<b>Meeting:</b> May 4, 2016	<b>Sublots:</b> 20 remain, 70 total
<b>Applicant:</b> Haslinger Holding Co.	<b>Zoning:</b> UR Urban Residential
<b>Engineer:</b> Rolling & Hocevar, Andy Planet	<b>Utilities:</b> Central water & sewer
<b>Parcel No.</b> 026-06C-10-028	<b>School Dist.:</b> Medina City
<b>Site Area:</b> 17.0767 acres	<b>Reviewer:</b> Rob Henwood

# DEERFIELD FARMS SUBDIVISION PHASE III

## CREATING SUBLOTS Nos. 51 THRU 70

*Figure 1: Phase 3 Street ROW and Sublot Reconfiguration*

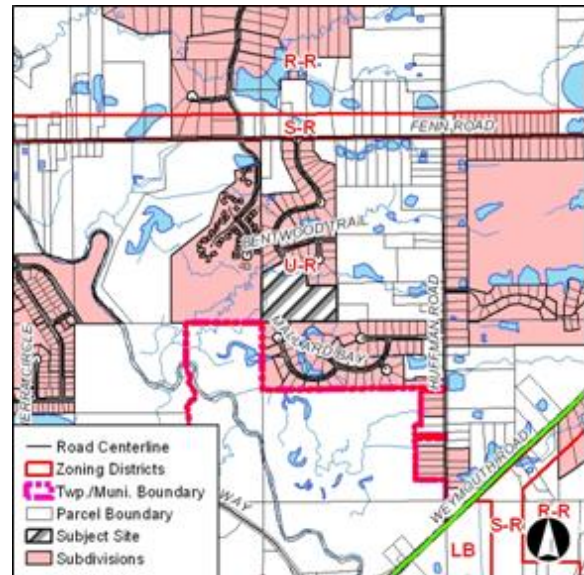
**Proposal:** The applicant proposes to revise the previously approved Preliminary Plan. The plan remains essentially unchanged with the exception of a shift in the configuration of the southern portion of Deer Lake Drive which shifts approximately 15 feet to the east to avoid impacting the existing wetlands. *Figure 1* below and to the left illustrates the street ROW and subplot configuration changes contained in Phase Three; blue lines indicate the previously approved Preliminary Plan and red lines indicate the proposed revisions. The Phase 3 Final Plat reflects the above referenced revisions.

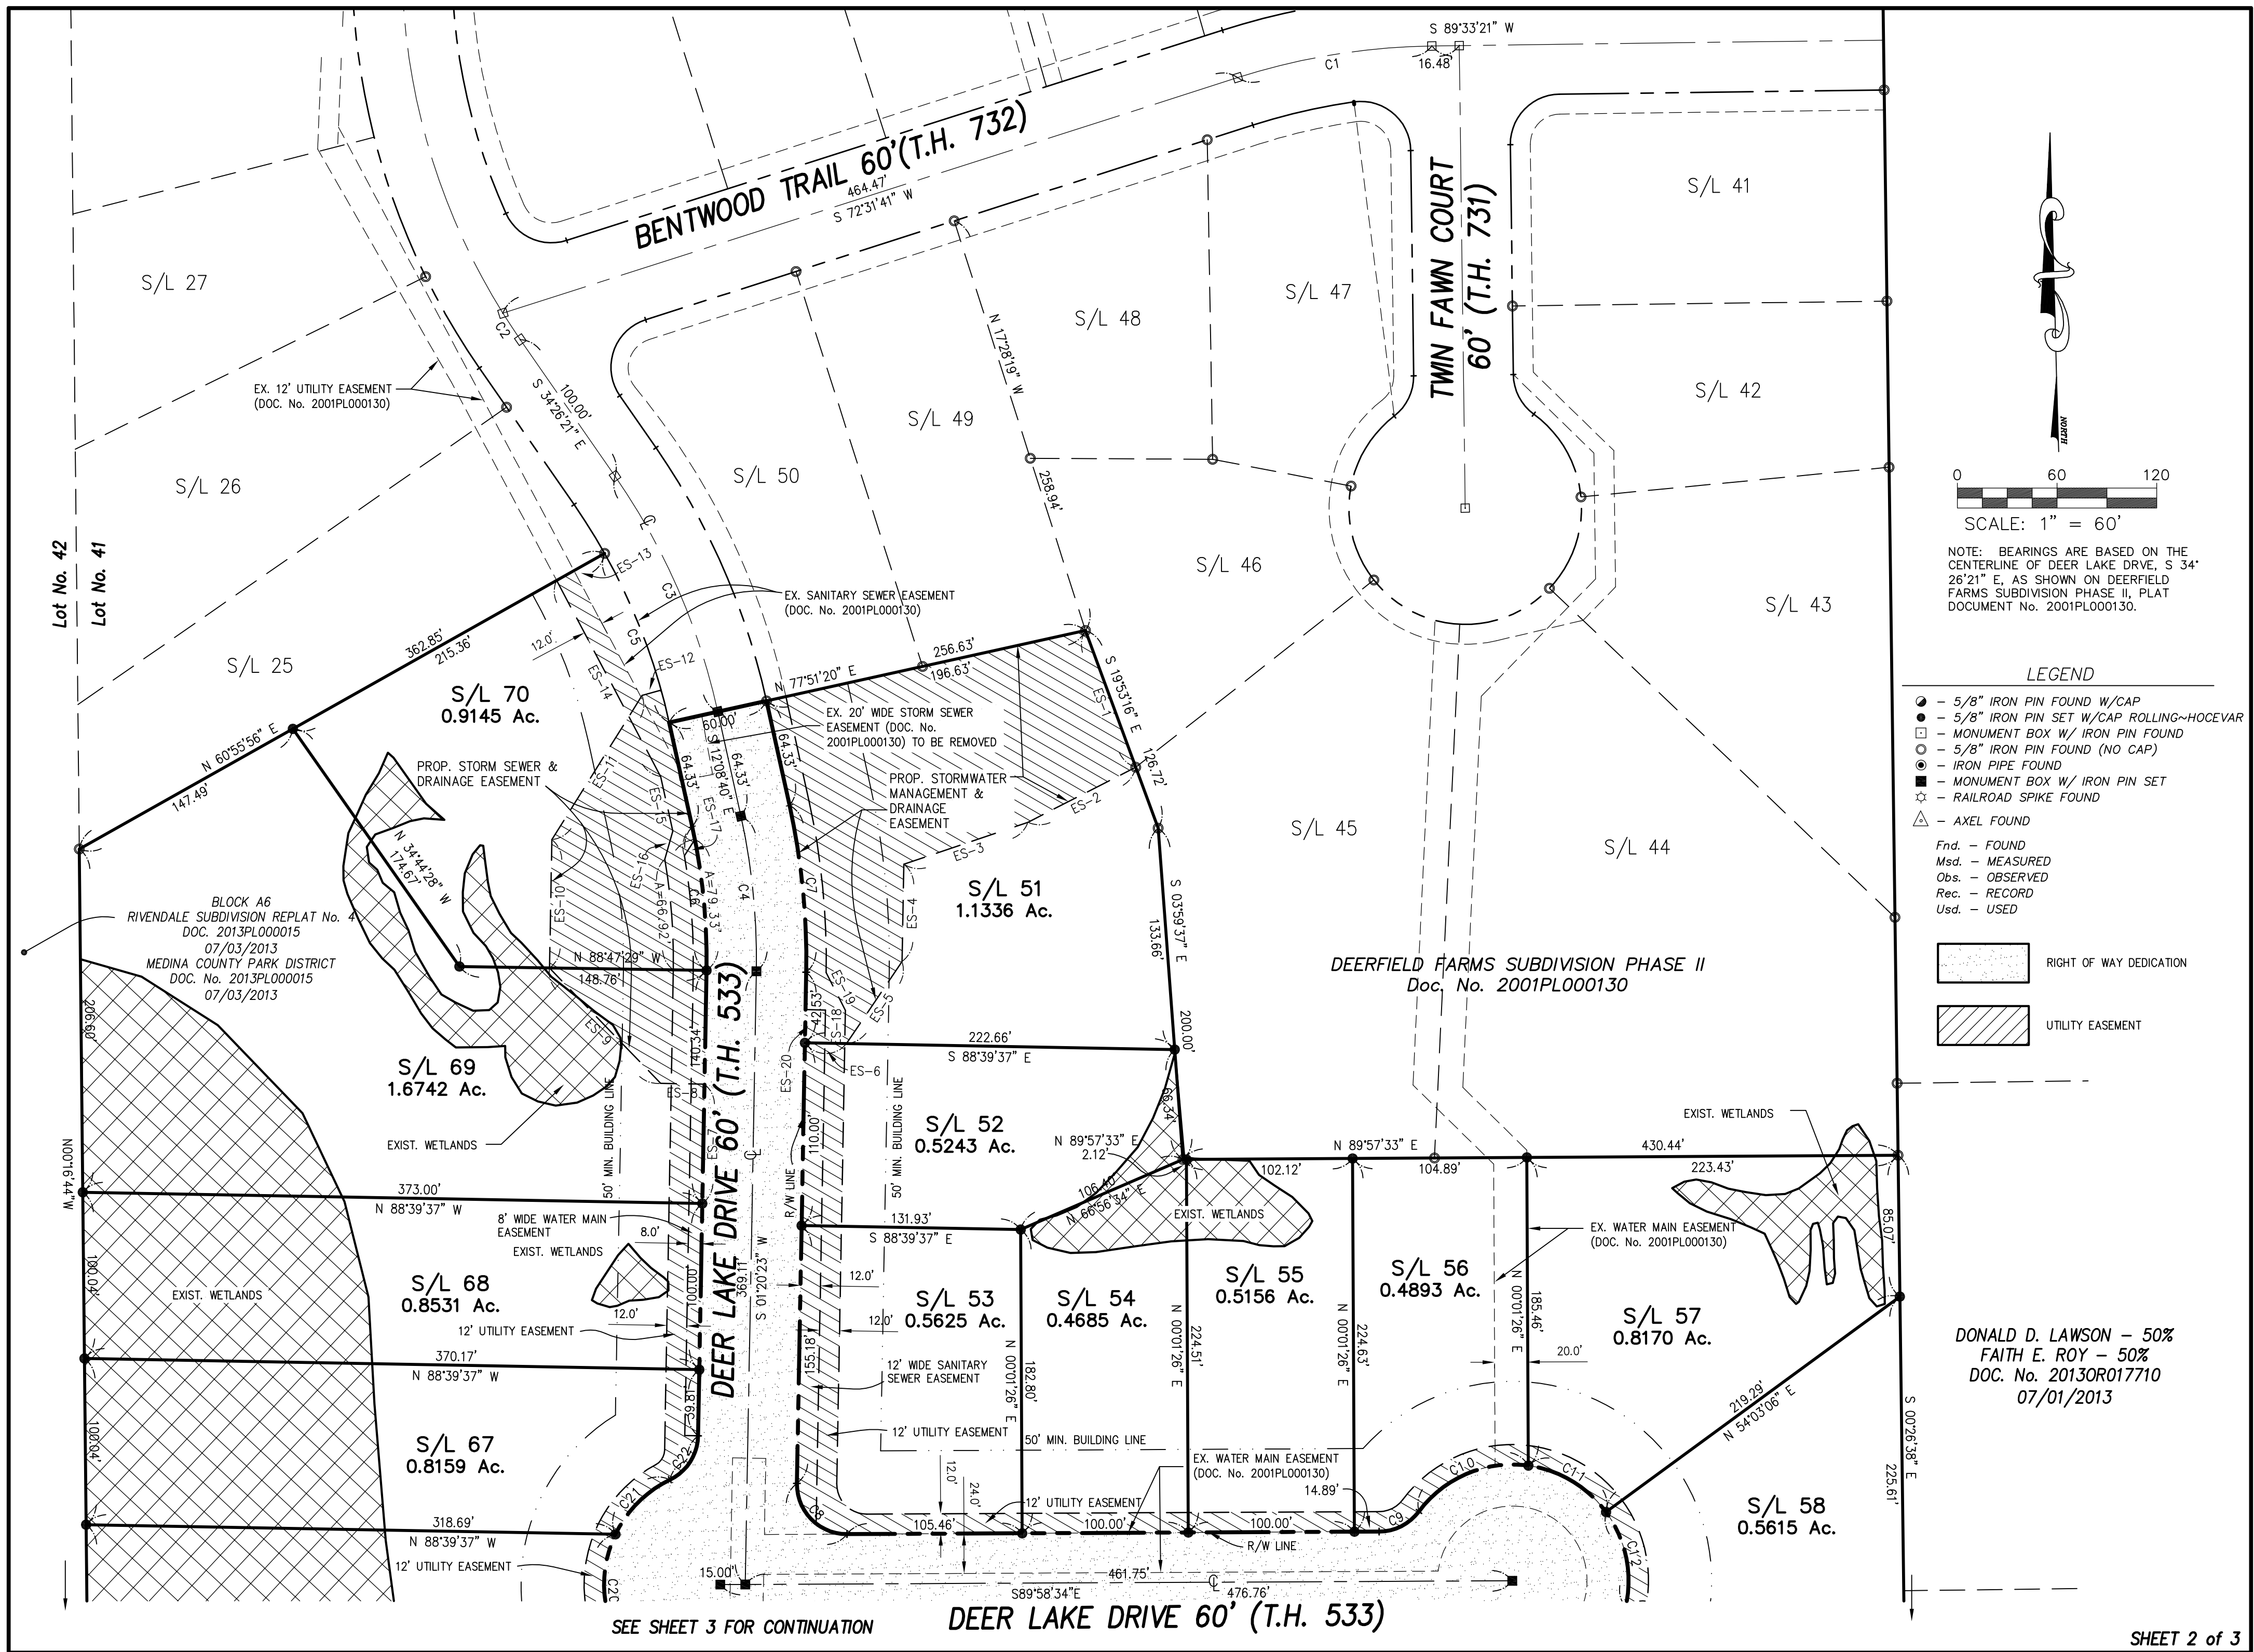
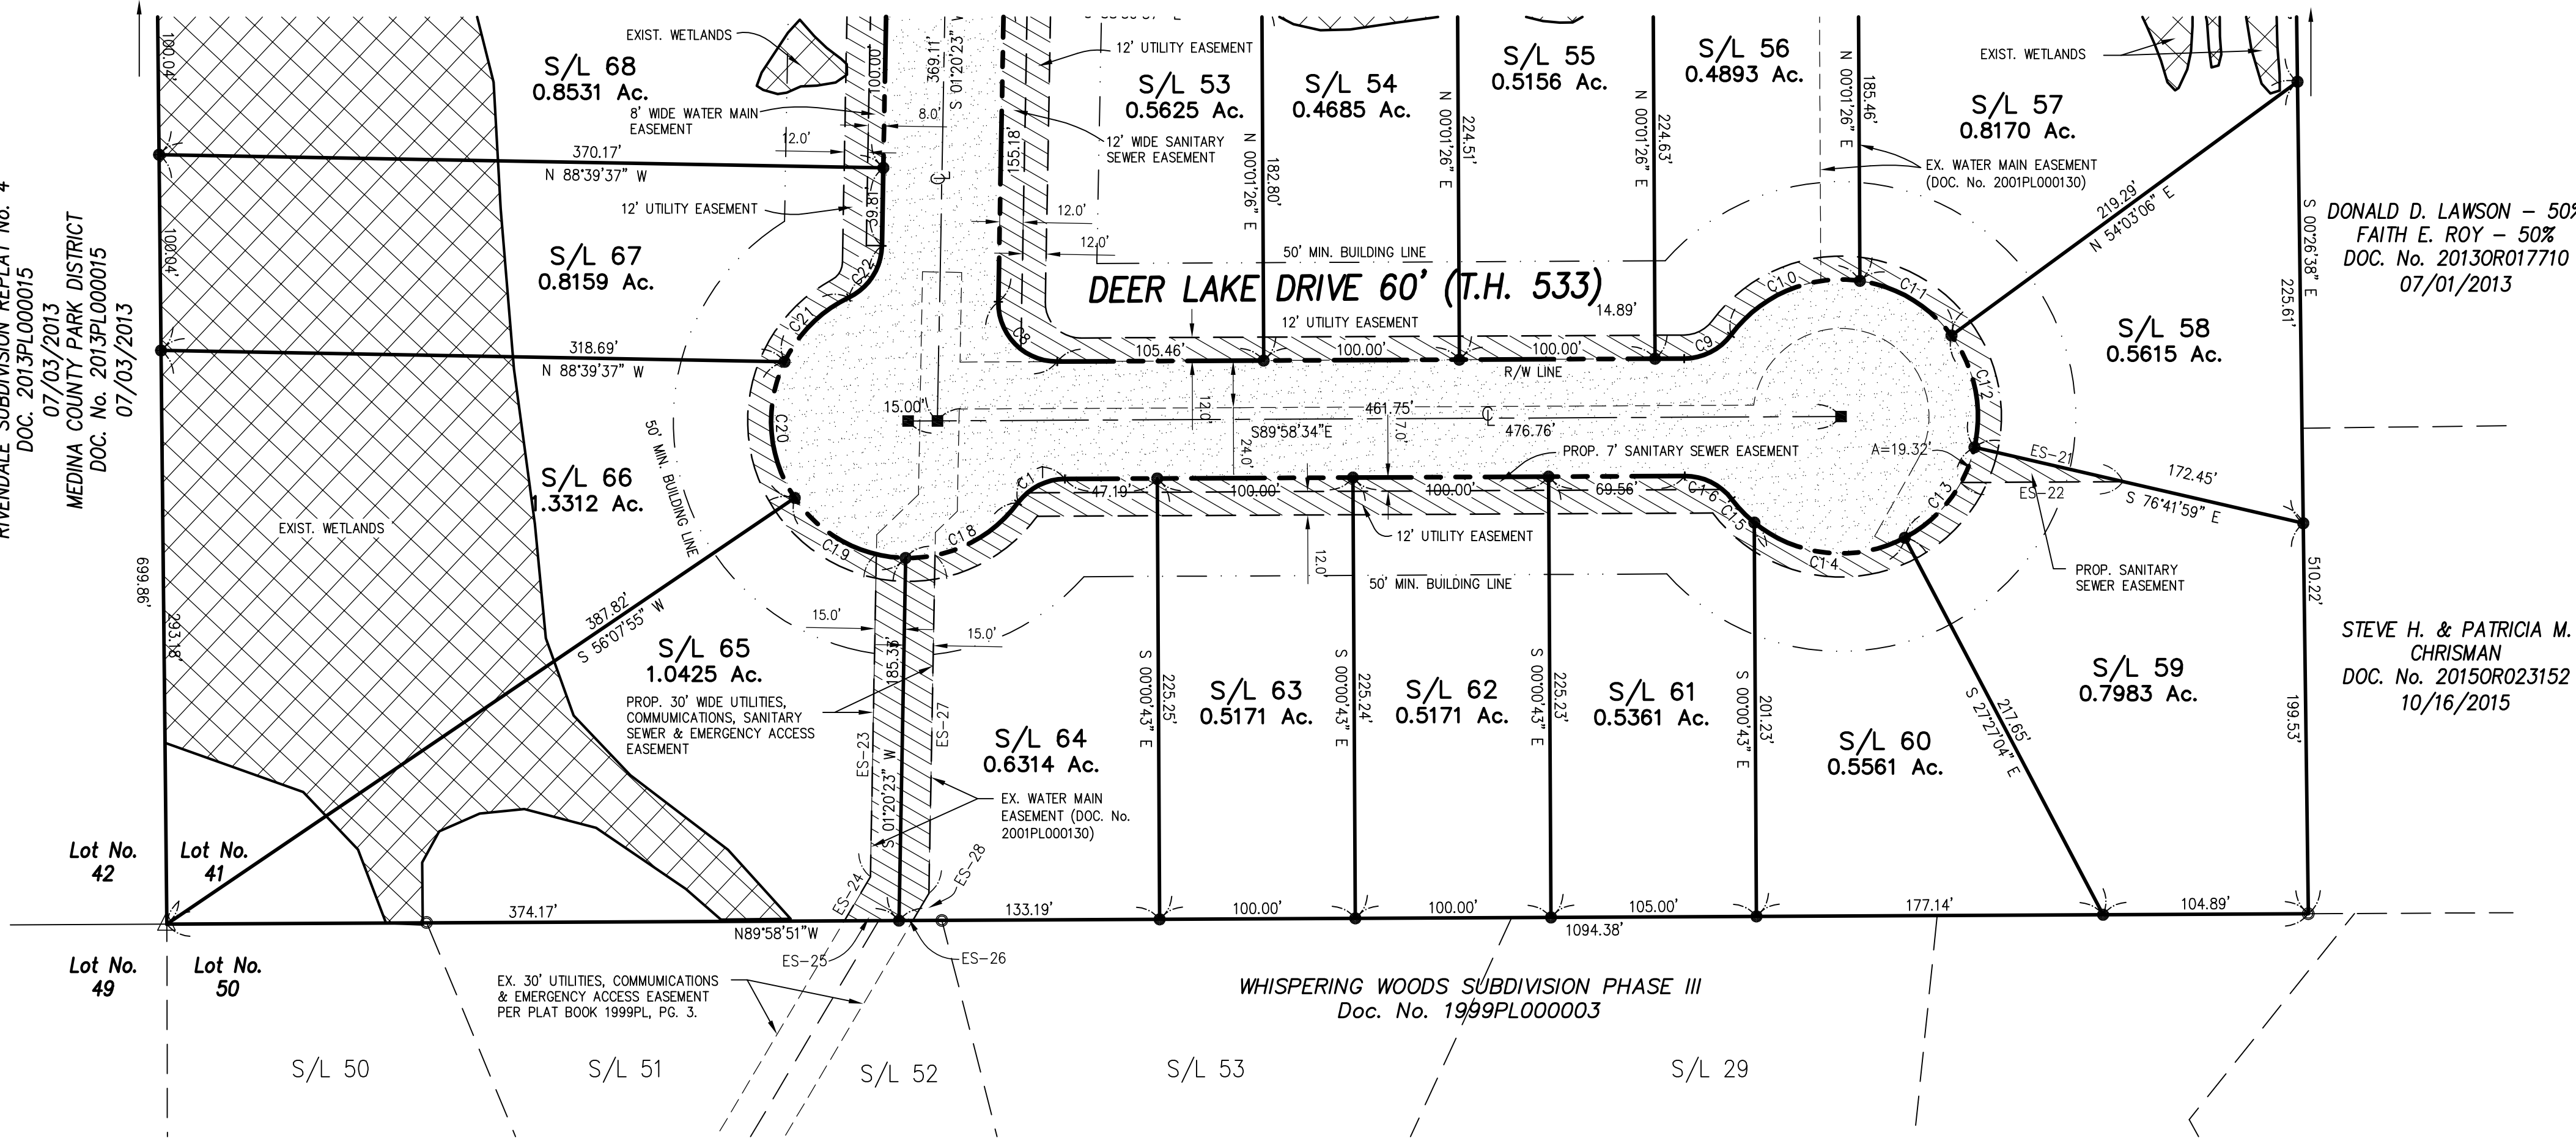
1. The following required data/information was not provided on or with the Final Plat (Subdivision Regulation section references are included):
  - a. An original mylar of the Final Plat. § 404(D)(2)d. **Submit the original mylar.**

- b. Signature and seal of a Registered Surveyor on each sheet. § 404(D)(2)f.16. **Add the surveyor signature and seal on each sheet of the plat.**
  - c. Notarized certification by the owner or owners of the subdivision and the offer of the dedication of streets and other public areas and that there are no unpaid taxes or assessments against the land contained in the plat. § 404(D)(2)f.17. **Provide notarized signatures of the owners.**

- d. Certification from the Township that the Final Plat as submitted is in compliance with local zoning standards and requirements. Such Certification shall be in the form of an executed signature block on the original mylar and signed by at least two of the Township Trustees. § 404(D)(2)g.1. **Provide signatures of at least two of the township trustees.**

- e. A subdivision served by a public central sanitary sewer [and public central water] shall be certified by the Sanitary Engineer stating all required wastewater disposal facilities and central water facilities have been satisfactorily installed or adequate financial guarantees have been approved. Such Certification shall be in the form of an executed signature block on the original mylar. § 404(D)(2)g.4. **Provide the signature of the Sanitary Engineer.**

- f. Certification of County Engineer that all required improvements have been satisfactorily installed or financial guarantees have been provided to cover all construction. § 404(D)(2)g.4. **Provide the signature of the Highway Engineer.**

- g. Acceptance of offers of dedication by County Commissioners, when all improvements have been constructed, or financial guarantees and construction agreements have been approved. § 404(D)(2)g.4. **Provide the signatures of the County Commissioners.**

2. Per the June 2014 Preliminary Plan approval, the emergency access drive for Deerfield Farms must be constructed to connect with the emergency access in Phase 3 of the Whispering Woods subdivision to the south when Phase 3 is constructed. The emergency access drive must be constructed utilizing eight inch thick paving consistent with public street standards (per the agreement between the township and the applicant's engineer). The language associated with the access easement must mirror the existing language used for the access easement in the Whispering Woods Subdivision. Evidence demonstrating the easement language has been approved by the Medina County Prosecutor's Office and Medina Township has not been submitted.

1. The above listed data/information must be provided on or with a corrected Final Plat.
2. All outstanding Planning Commission requirements for the Revised Preliminary Plan must be satisfied prior to the Director signing the Final Plat.
